STAFF REPORT
KETCHUM PLANNING AND ZONING COMMISSION
REGULAR MEETING OF JUNE 25, 2024

PROJECT: Papillon Condos (formerly Bohica Mixed-Use)

APPLICATION TYPE: Design Review Amendment

REQUEST: Design Review amendment for revisions to the front façade of the building along N Washington Ave.

1 Elevation - North
A-203 1/4" = 1'-0"

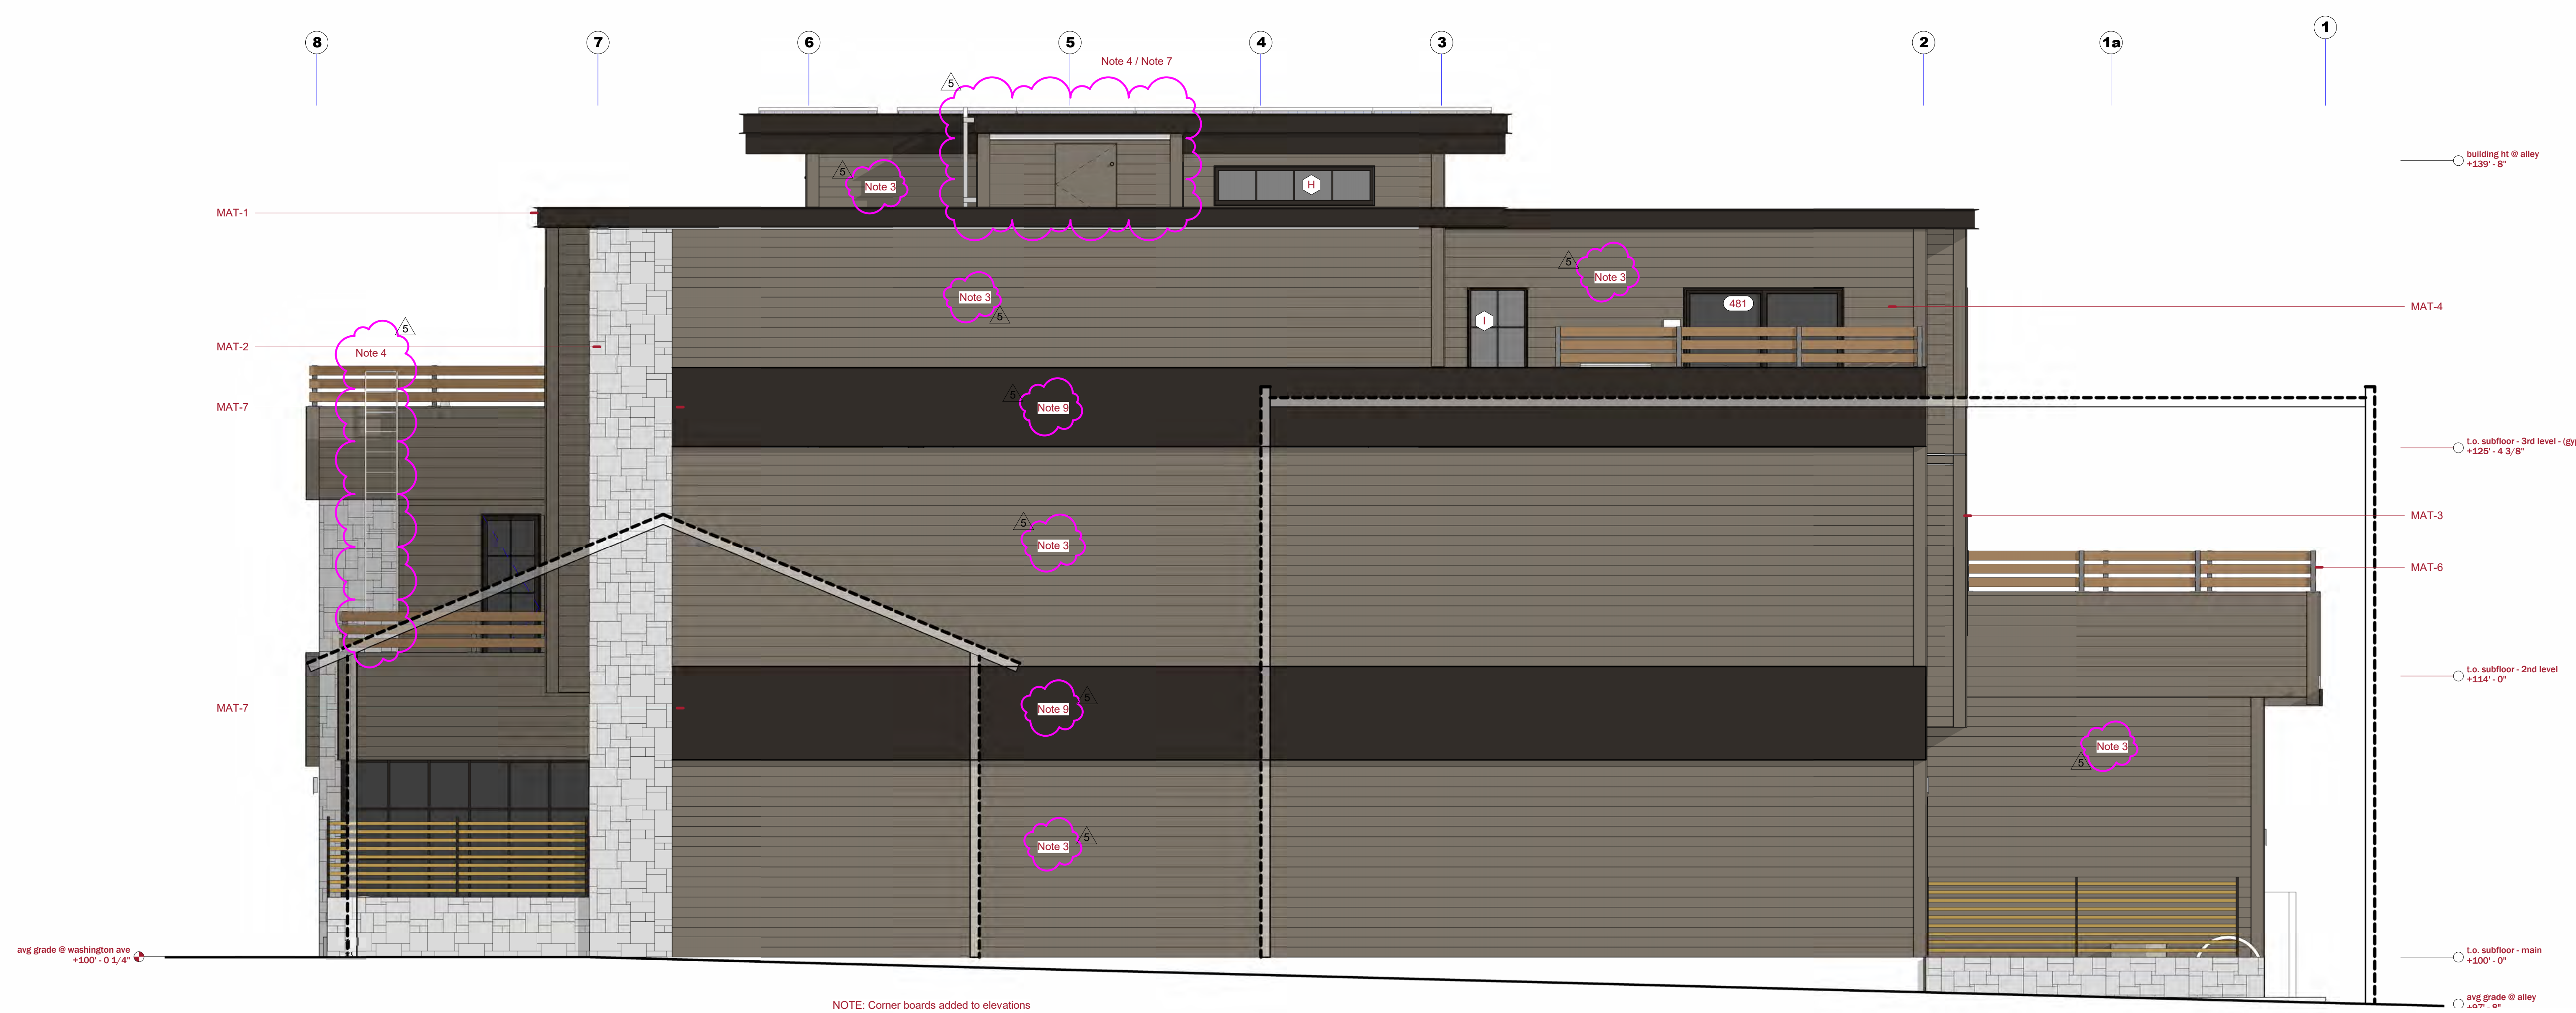
- Note 3 – Wall siding changed to horizontal orientation
- Note 4 – Roof access ladders added
- Note 7 – Mechanical room added to roof level
- Note 9 - Horizontal 'banding' on North side of project to be metal paneling to match steel fascia material

NOTE: Corner boards added to elevations

Horizontal siding and vertical corner boards added to rendering

ROOF FRAMING PLAN

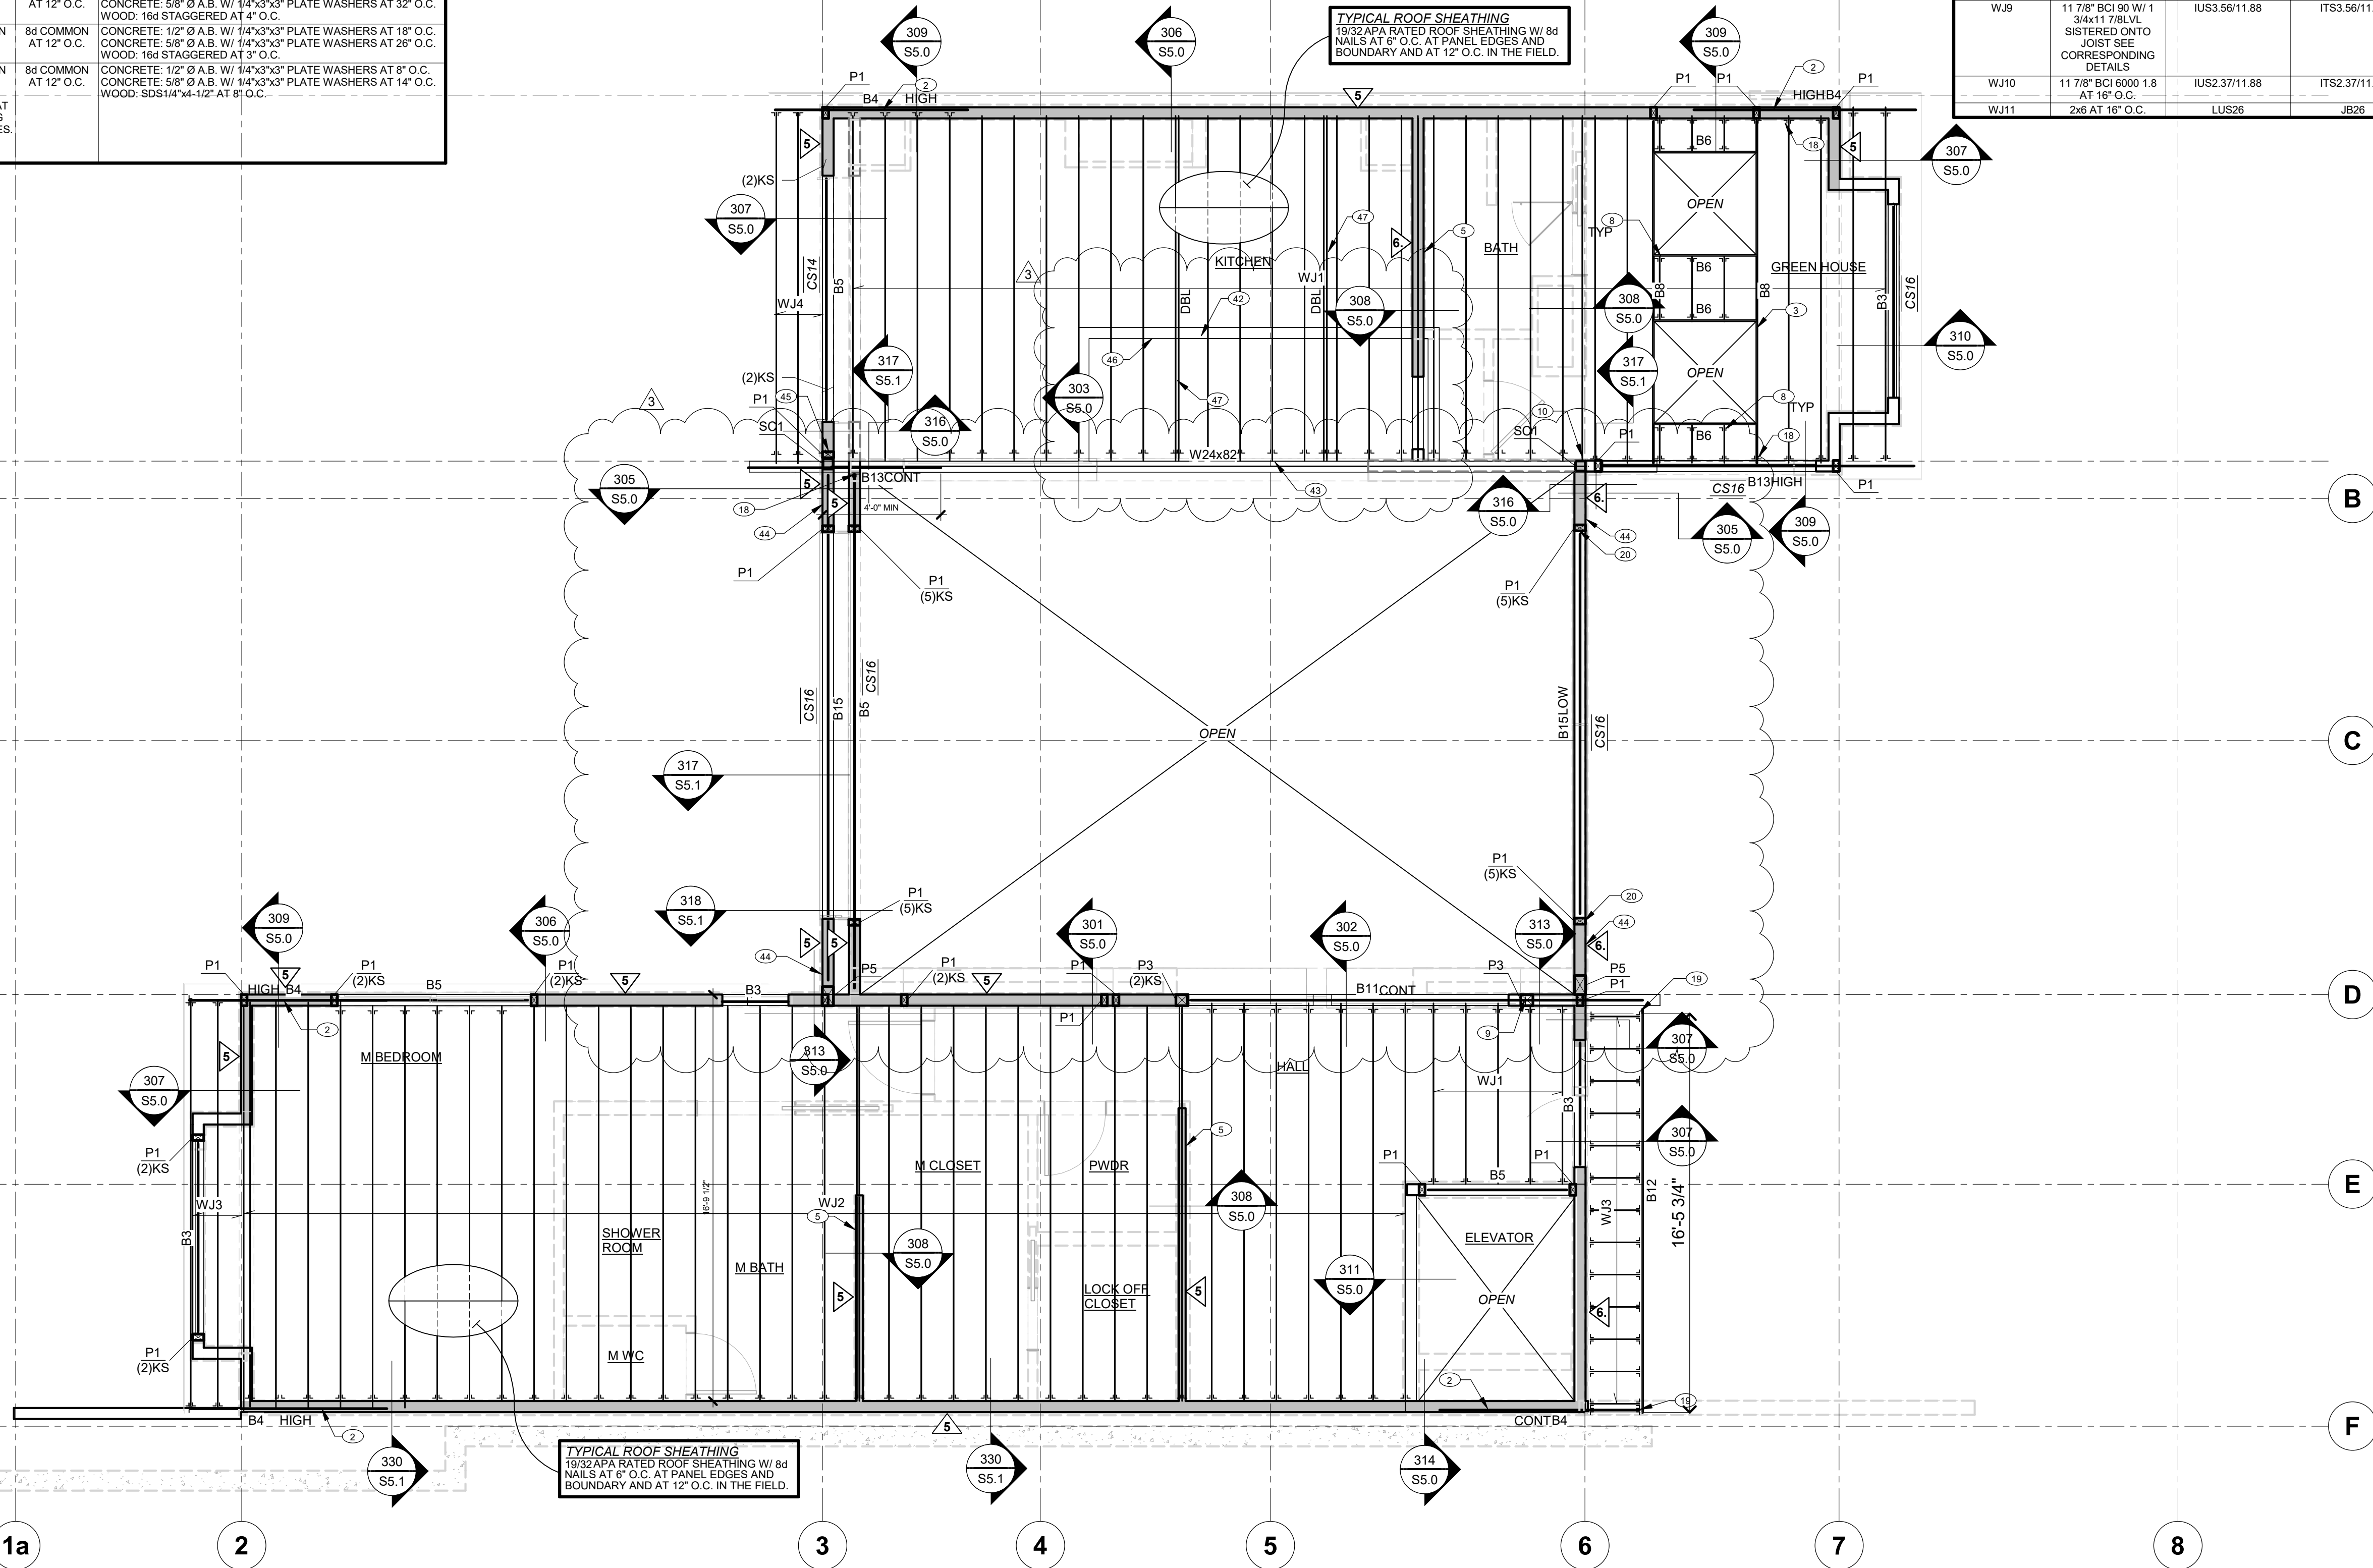
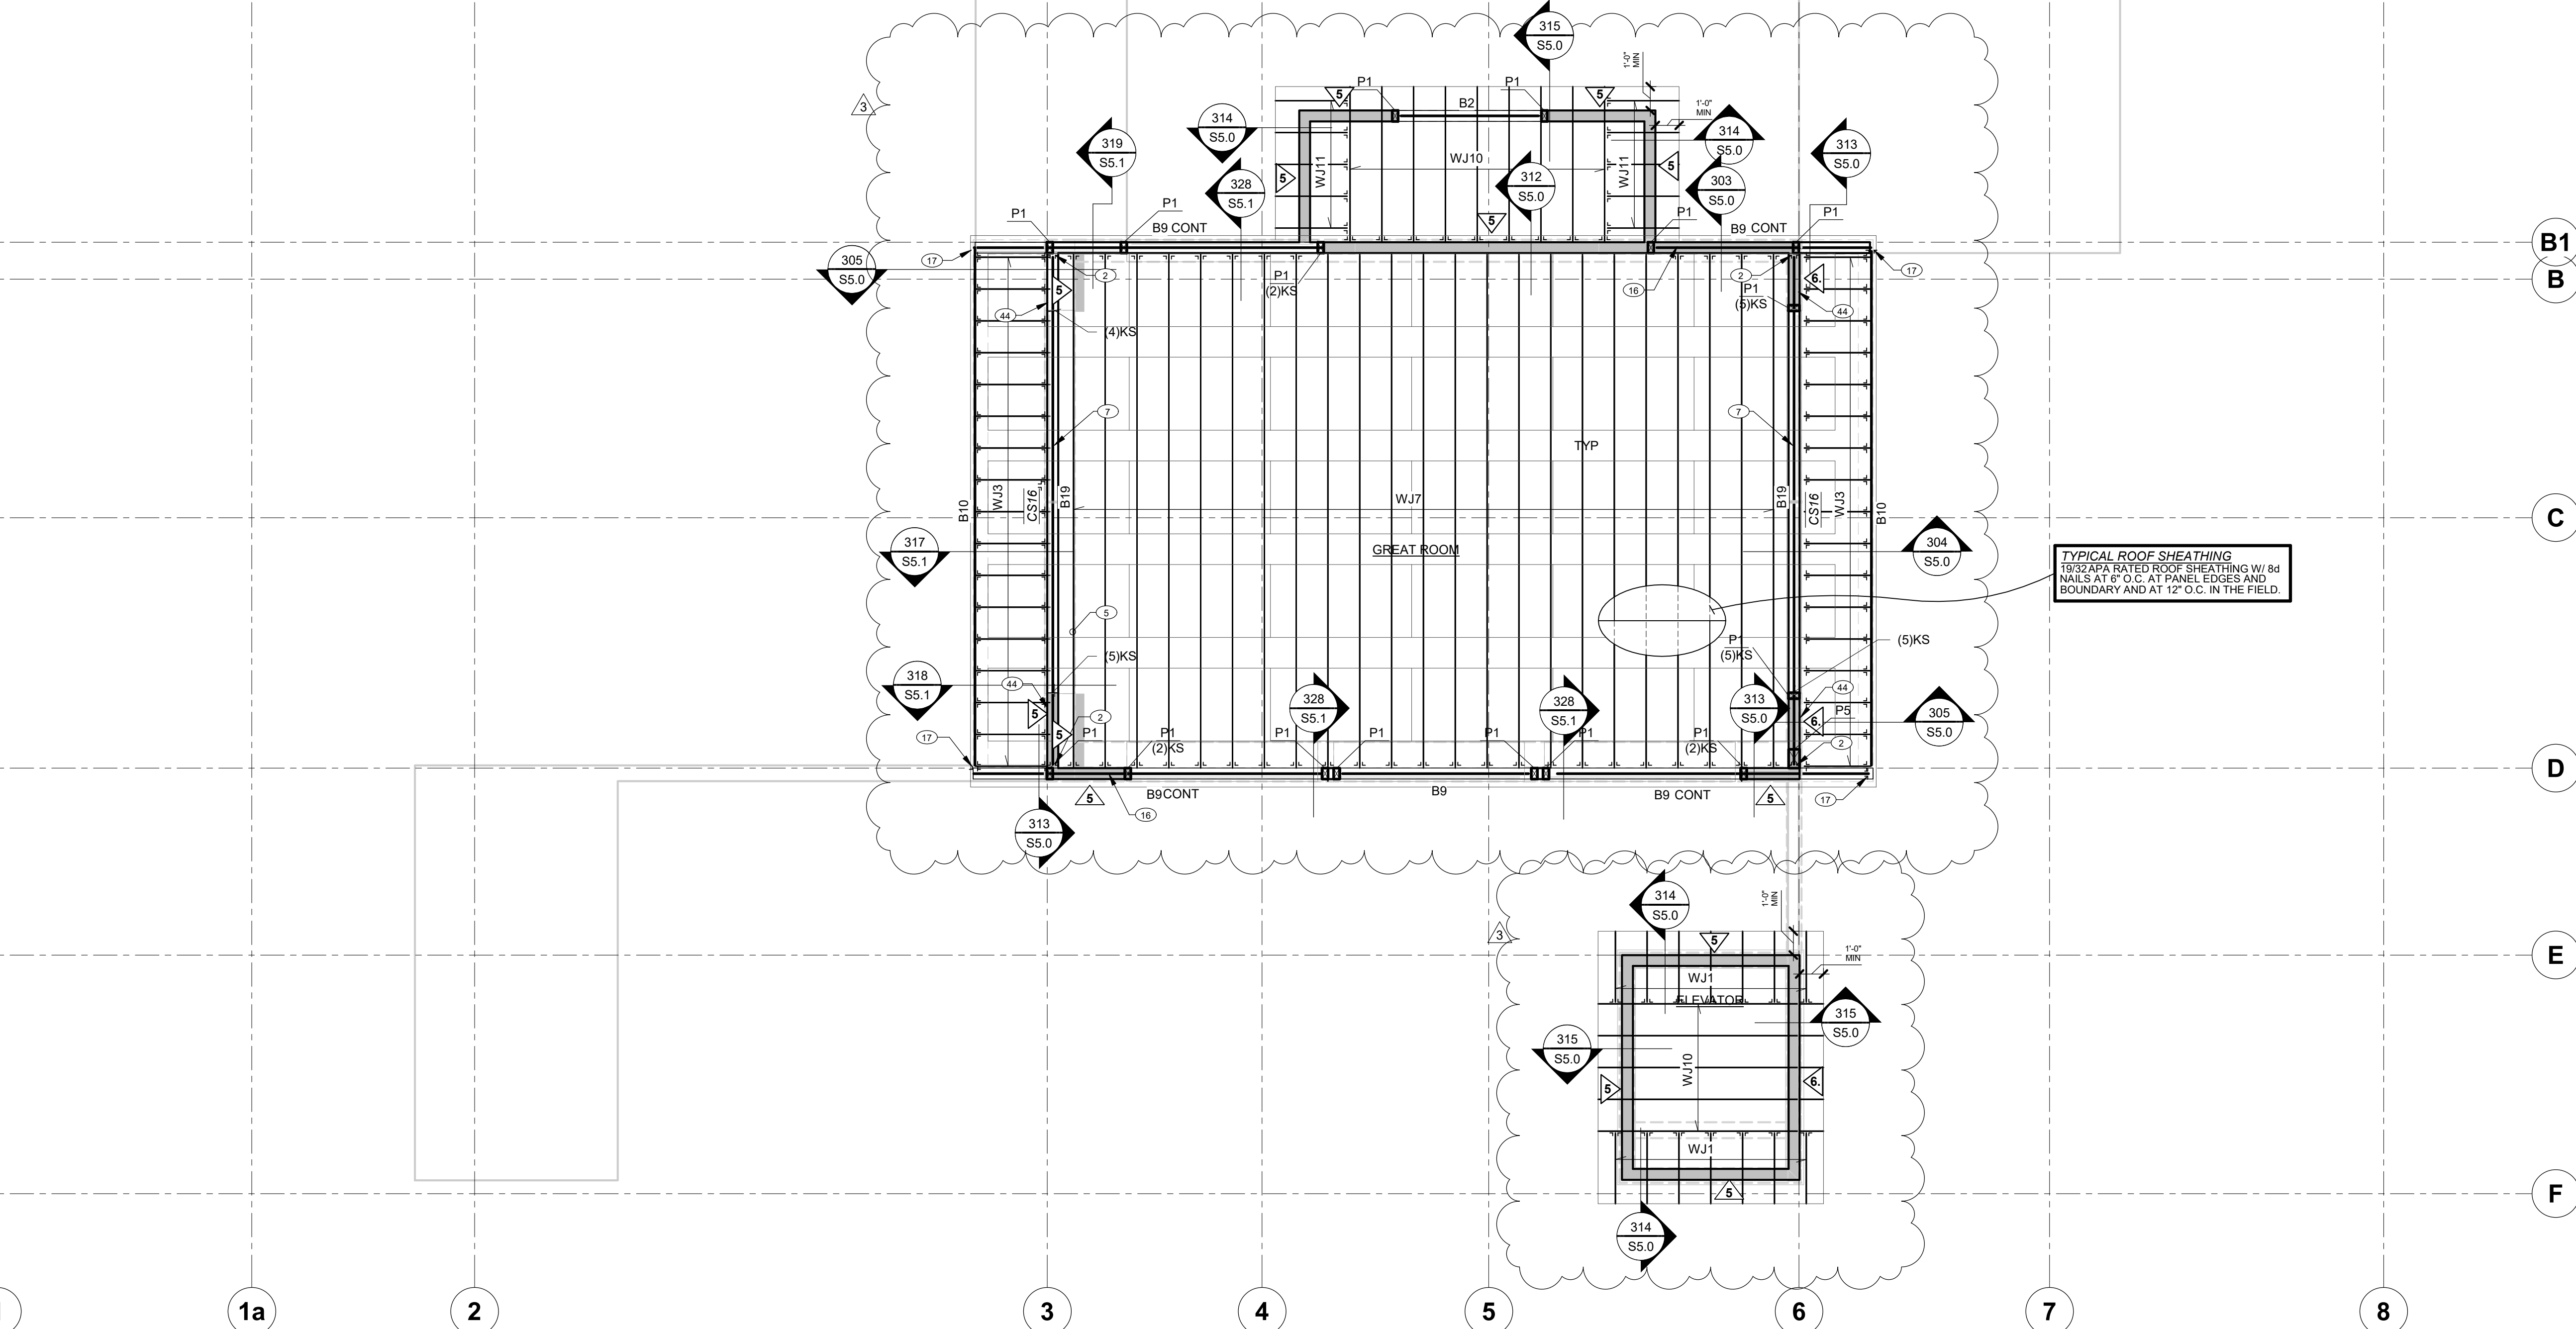
- 55 square foot mechanical enclosure added to upper secondary roof, north side. Building height does not change. Building setback is not affected. Existing upper primary roof to extend over proposed mechanical enclosure.
- Original proposed vertical siding to be horizontal siding. No vertical siding is proposed for the project.
- All outside corners at horizontal siding to have 2x8 vertical corner board.
- Horizontal 'banding' on North side of project to be metal paneling to match steel fascia material.
- Horizontal roof awning (aligned with upper secondary roof) at East and West omitted.
- New S2.5 High Roof Framing Plan sheet added to permit set for clarity:
 - Bohica - 2023-08-29 - S2-5

Changes to structural sheets to reflect changes to roof plan and details.
